**Durban Container Terminal Berths 203 to 205 Reconstruction, Deepening and Lengthening
Clarification Register Rev.10
TNPA/2023/08/0003/38950/RFP**

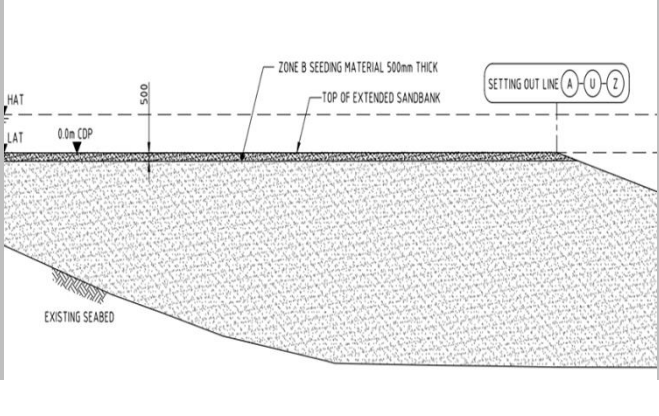
<p>In the Environmental Authorisation document, we cannot find anything mentioned about overflowing, but in the EIA following is stated:</p> <ul style="list-style-type: none"> • <i>Page 33 - In addition, choking of the dredge hopper overflow is also suggested so that the fluid level in the hopper is maintained and as a result no air is taken down with the suspension leaving the hopper.</i>

<ul style="list-style-type: none">• <i>Page 34 - he dredges hopper overflow will be choked with a fully automated computerised process controller to ensure that there is a constant fluid level in the hopper is maintained and thus no air is taken down with the suspension. This has been shown to significantly decrease turbidity in surrounding waters.</i> • <i>Page 67 - The dredge hopper overflow will be choked with a fully automated computerised process controller that can ensure dynamic adjustment of the valve in the overflow funnel which chokes the flow in such a way that a constant fluid level in the hopper is.</i> • <i>Page 103 - Choking the dredge hopper overflow with a fully automated system is also recommended. In this scenario, a computerised process controller ensures dynamic adjustment of the valve in the overflow funnel which chokes the flow in such a way that a constant fluid level in the hopper is maintained and, as a result, no air is taken down with the suspension leaving the hopper. This results in a significant decrease in turbidity.</i> <p>From the EIA it is understood that overflowing is allowed, as long as the flow of water leaving the overflow tube is “choked” meaning the use of a ‘green valve’ in the overflow. The Green Valve reduces the air</p>	<p>Refer to #17 above.</p>
